Memorandum

To: NYISO

FROM: David B. Patton, Pallas LeeVanSchaick, and Joe Coscia

RE: Technology Choice for the 2025-2029 Demand Curve Reset (“DCR”)

Figure 1: CAF Effects on 2-Hour Battery Reference Points

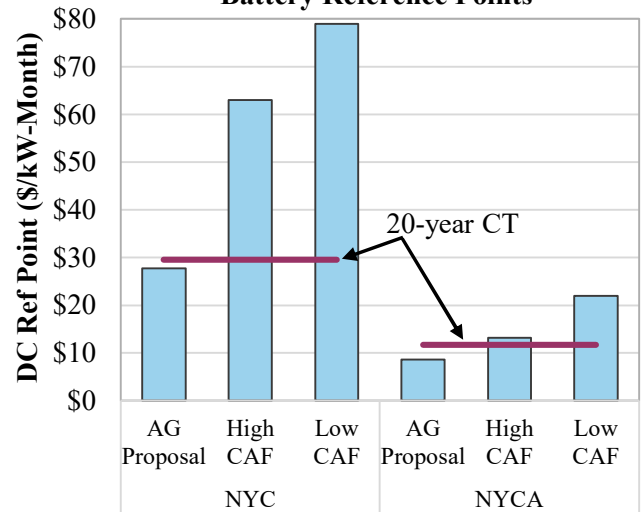
- AG underestimates the Net CONE of the battery because it does not properly consider the impact of falling Capacity Accreditation Factors (“CAF”) over the 20-year amortization period. A more reasonable analysis, shown in Figure 1, would indicate that the demand curves under the 2-hour battery would exceed those of a combustion turbine.

Regarding the first concern, a falling CAF over the life of a 2-hour battery will likely cause it to lose revenue in future years, thereby *raising its initial Net CONE*. Based on forecasted trajectories for the CAFs, it is unlikely to remain the demand curve reset unit after this cycle. If one assumes the demand curve is set based on a CT in the next cycle, the *current* Net CONE for the 2-hour battery and the corresponding demand curve reference points would rise sharply as shown in Figure 1. Even if one adopts an optimistic assumption that that CAF will fall less (i.e., the “high CAF” scenario), the reference point and resulting capacity prices would be higher than for a 20-year CT in all areas.

Figure 2: Forecasted Prices in Reset Period

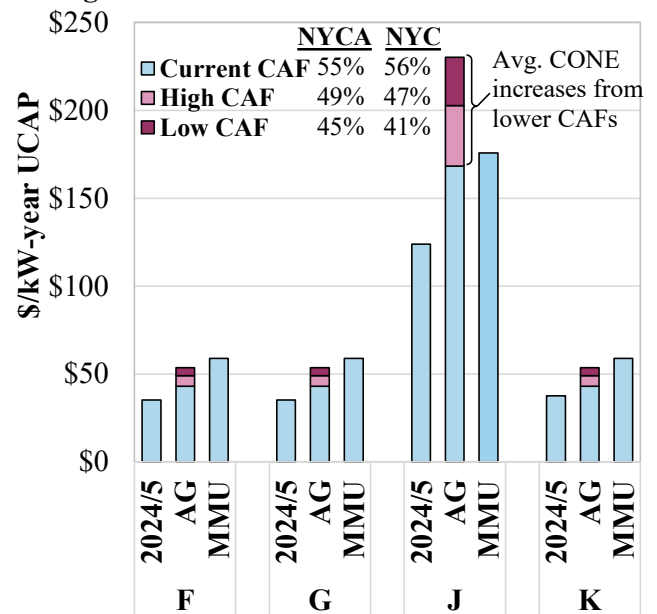
However, even if one accepts the Net CONE estimated by AG for the 2-hour battery, it will still likely produce higher prices in New York City over the 4-year demand curve reset period than a 20-year CT (the second concern listed above). Figure 2 compares forecasted clearing prices over the next four years under the current (2024-25) demand curves and the AG and MMU-recommended demand curves given the current capacity surplus. For the AG-recommended

This analysis shows that the AG proposal is likely to produce much higher prices in New York City after year 1 of the demand curve period than the MMU-recommended curves. Prices after year 1 in the rest of the state area may be comparable under the AG and MMU-recommended curves in the “Low” CAF case, with the MMU-recommended curves producing only slightly higher prices in the optimistic “high” CAF case.³

Figure 3: Future Expected CAF Changes in NYC for the 2-Hour Battery

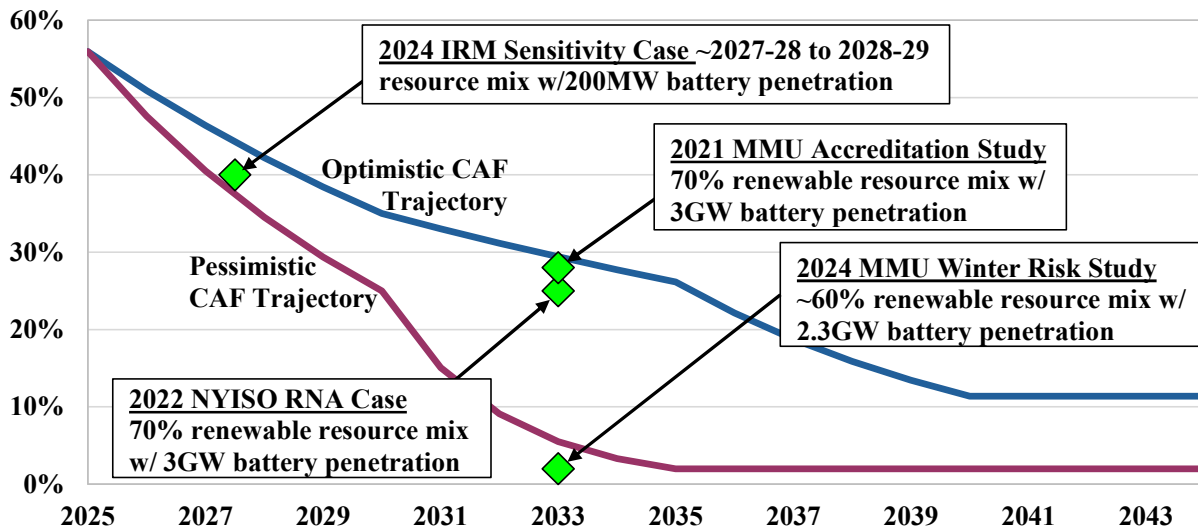
All of these studies indicate that we should expect the 2-hour battery’s CAF to decline rapidly in the near future, although there is a wide range in the specific projections. Importantly, *none of these studies assume the State achieves its 2030 goal of 6 GW of battery storage installations.* Higher penetration of battery storage will tend to reduce their future CAF levels. Figure 3 shows the results of these studies for NYC (displaying the two studies of 70 percent renewables in 2033 given current progress) and includes realistic optimistic (i.e., high CAF) and pessimistic (i.e., low CAF) future CAF trajectories that we use to analyze 2-hour battery investments.

This figure shows that even in the optimistic case, CAF levels for a 2-hour battery in New York City will drop from the current 56 percent to slightly over 11 percent by 2040. The optimistic

Figure 4: Battery Net CONE in NYC with Optimistic CAF

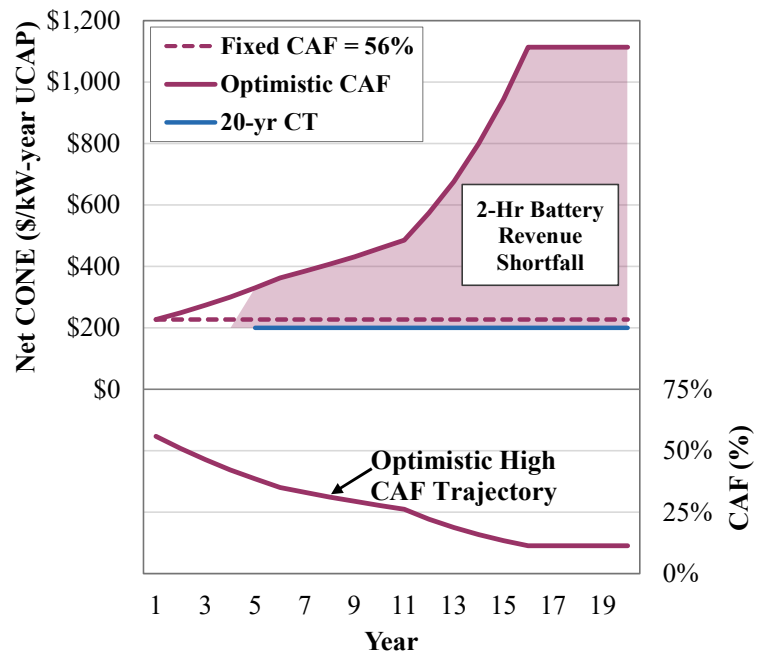
To illustrate how the CAF affects the incentives to invest in a 2-hour battery resource, Figure 4 shows the Net CONE of a battery in New York City over 20 years as the CAF falls in an optimistic case. It compares this to the Net CONE of the resource if the CAF were to remain fixed at the current level and to a CT amortized over 20 years.

Figure 4 shows that if the CAF falls from 56 percent in Year 1 to 11 percent by year 20, the Net CONE of a 2-hour battery would rise by almost 400 percent to \$1113 per kW-year (UCAP). As the CAF falls, its costs will quickly become much higher than the Net CONE of a CT. This should cause the CT to become the demand curve technology, causing a predictable

Figure 5: Capacity Revenue to 2-Hour Battery in NYC

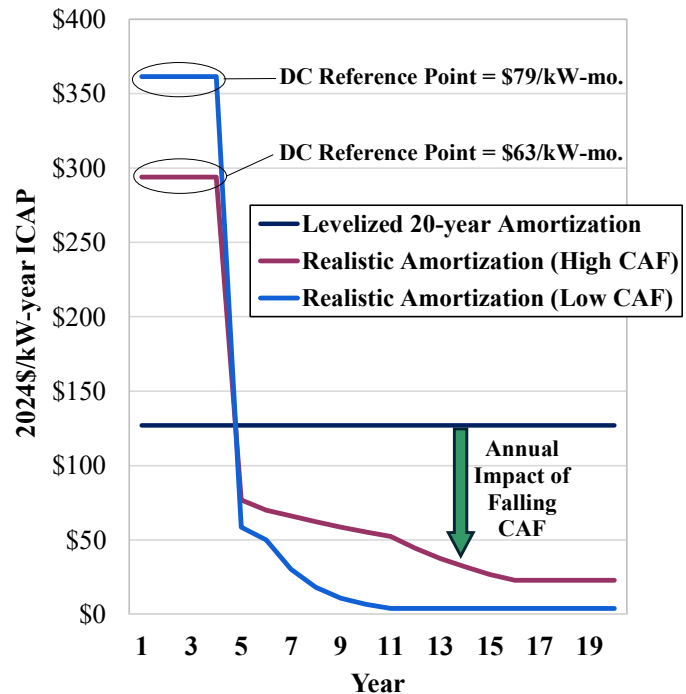
Figure 5 illustrates how a New York City battery investor’s annual capacity revenue needs (in ICAP terms) would vary over the 20-year period based on the “Realistic High” and “Realistic Low” CAF trajectories. The revenues fall after year 4 because:

The falling capacity revenues after year 4 must be offset by higher revenues in the first four years when the battery would set the demand curve. These higher initial revenues would offset the falling revenues in future years to provide the same revenues as the 20-year levelized revenues shown in the figure.

This indicates that it is unreasonable to assume the 2-hour battery can be amortized evenly over 20 years. AG’s assessment of the 2-hour battery storage is incomplete because it does not reasonably consider capacity accreditation risks. A reasonable evaluation of these risks would reveal that the 2-hour battery is more expensive than a CT amortized over 20 years. The analyses shown in Figures 4 and 5 are shown for other zones in New York in the Appendix to this memo.

Figure 7: Capacity Revenues to 2-Hour Battery if CTs Fully Amortized by 2040

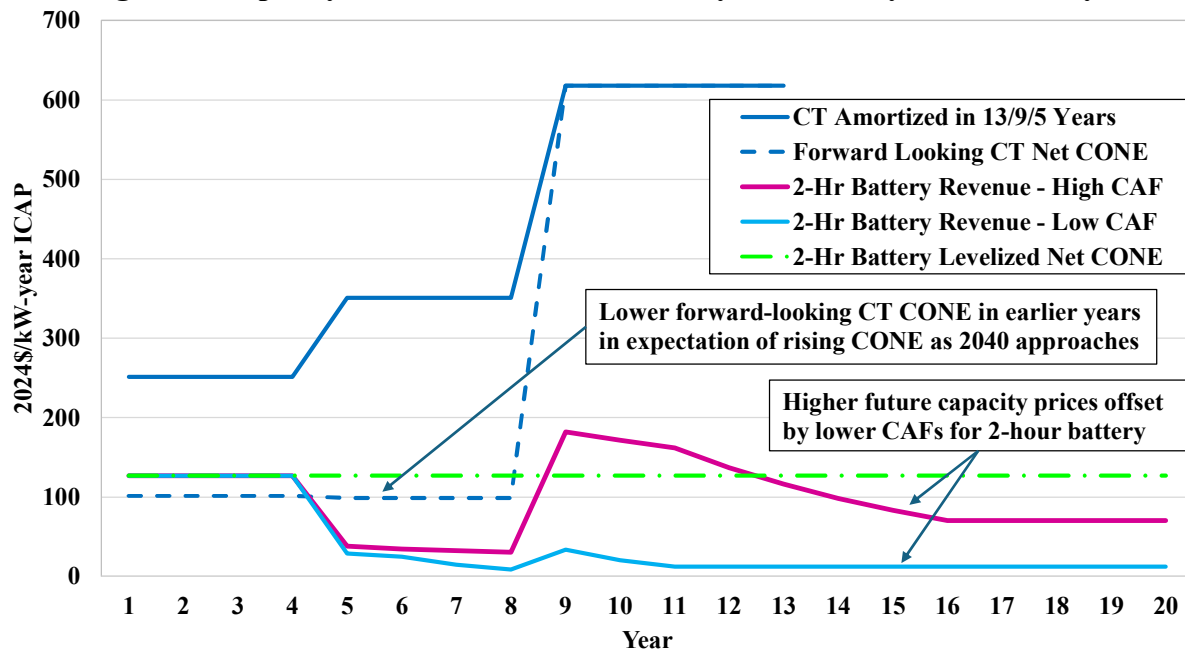
Figure 7 shows the annual capacity revenue that would be recovered by a 2-hour battery in each year of the investment assuming it receives: (a) the 20-year levelized amortized revenue requirement in Years 1 to 4, (b) capacity revenue based on the Net CONE of a CT entering in 2031 and fully amortized before 2040, and (c) capacity revenue based on the Net CONE of a CT entering in 2035 with a 5-year levelized amortization and continuing at this level through the remainder of the 20 years of the 2-hour battery investment. These are shown for our realistic high and low CAF scenarios.

In the high CAF scenario, the 2-hour battery developer earns 17 percent less capacity revenue (on a net present value basis) than needed to make the investment profitable. In the low CAF scenario, the 2-hour battery developer earns 54 percent less capacity revenue than needed to make the investment profitable. The figure shows that if capacity prices rose in the last five years before 2040 and continued through 2046, it would tend to increase revenues to a 2-hour battery investment, but not enough to make the investment profitable because of the significant CAF degradation. Hence, even if a CT had to be fully amortized before 2040, it would not support the selection of a 2-hour battery as the demand curve unit technology.
